Engineering Change Notice

Title	Azure Support Cable
ECN Number	ECN-0128
Equipment	Azure 2000 & Azure Shadow.
Author	Alwyn Fernandes
Drawing Number	17-02-0170A
Date	28/07/00

Top right hand side

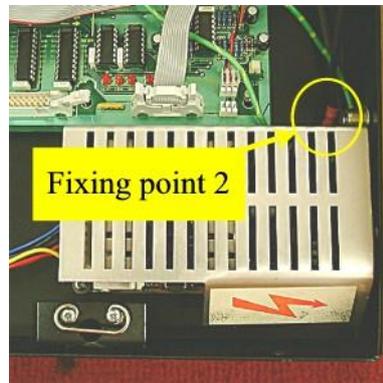
The length of the Azure Support cable is critical. It has to be exactly 520mm long – see drawing 17-02-0170A for further details.
Both the fixing points have now changed for this cable – this are indicated below.
